ADDENDUM #2

**Columbia Public Schools
New SW Middle School Site Package**

PWA PROJECT NUMBER: 201621.01

ADDENDUM NO. 2

RETAINING WALL SECTION

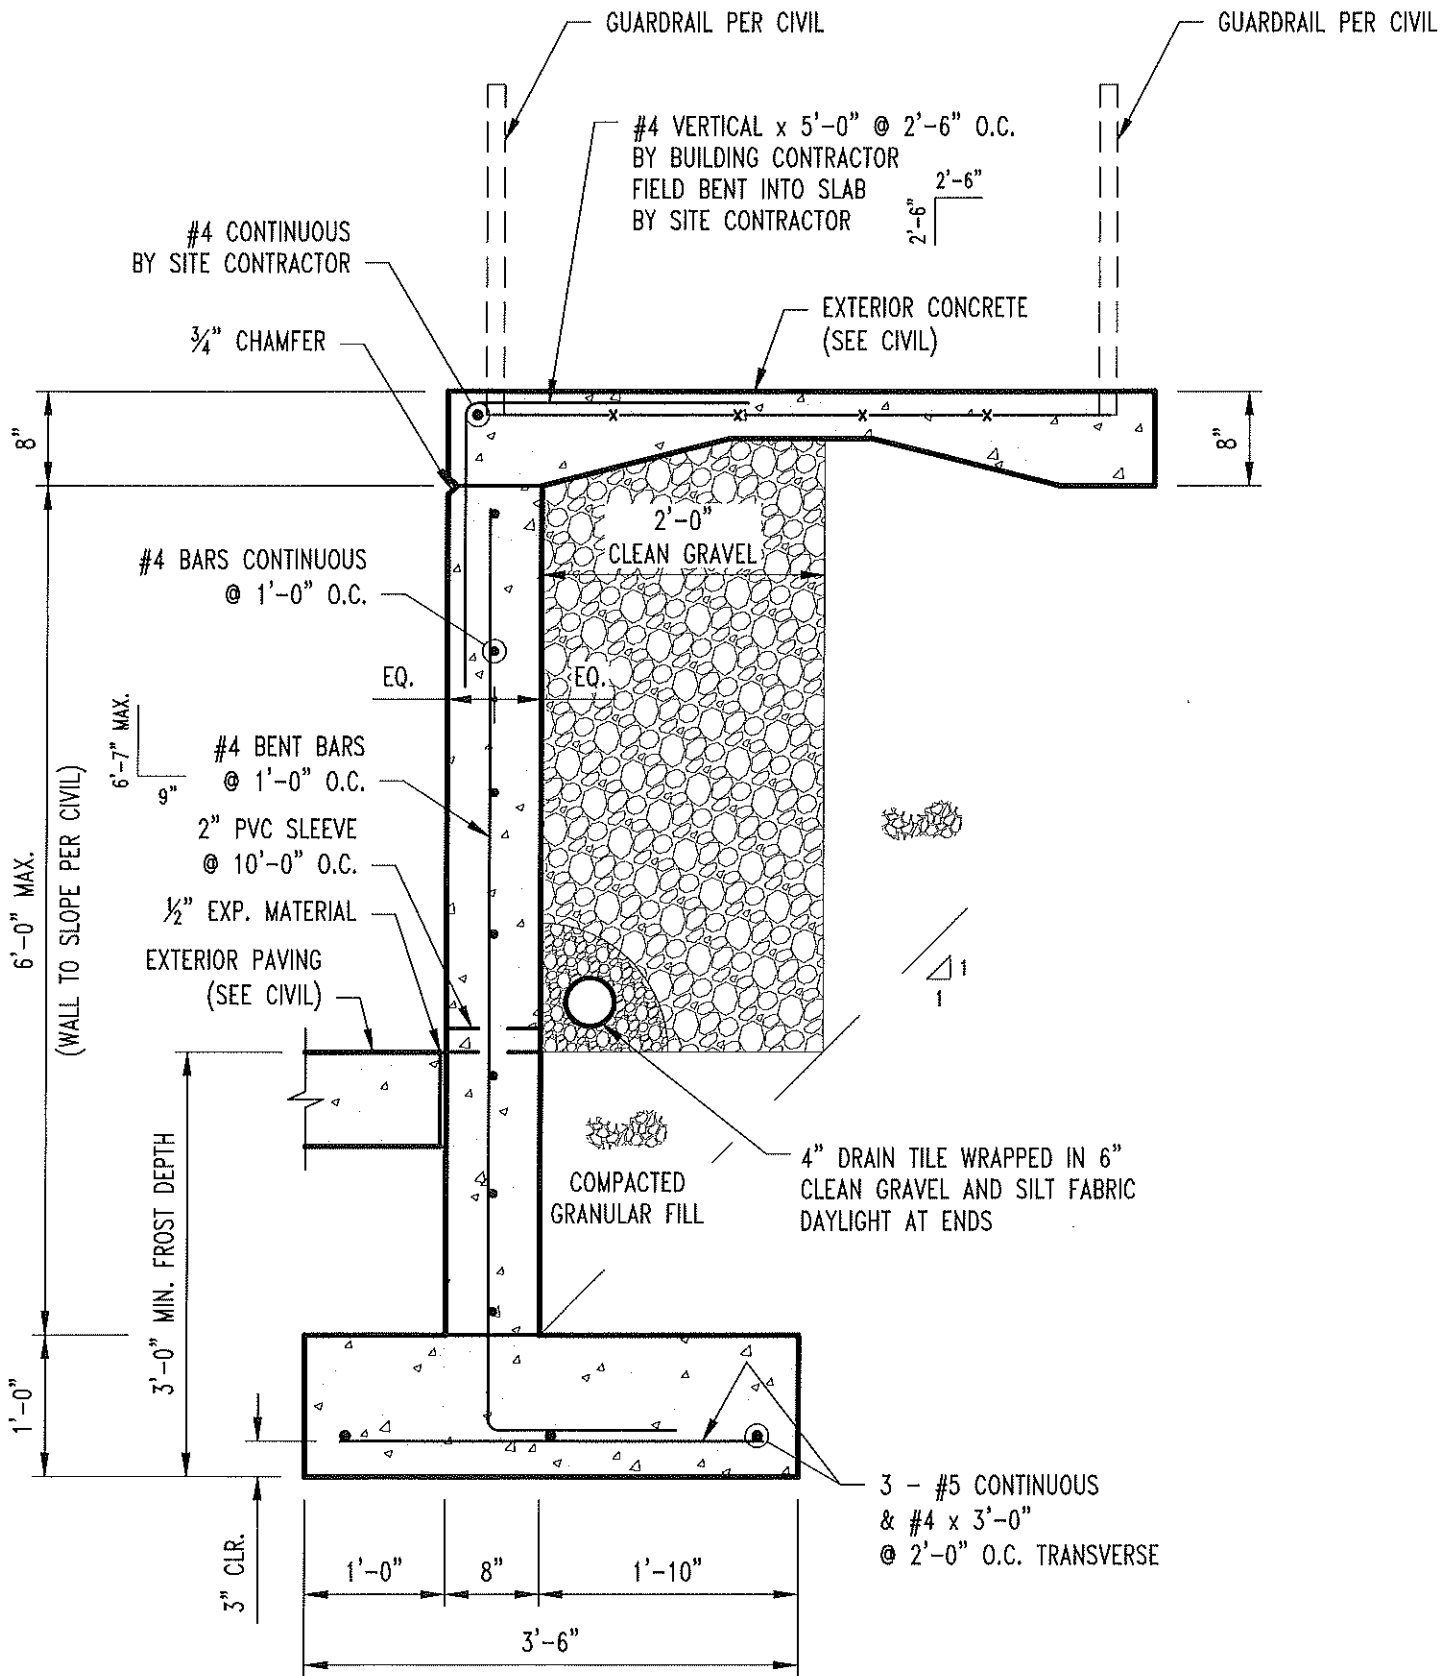
- E. Attached is the detail for the sidewalk connection at the dock wall prepared by Crockett Engineering Consultants that was indicated in Addendum No. 1 Item No. 2 H.
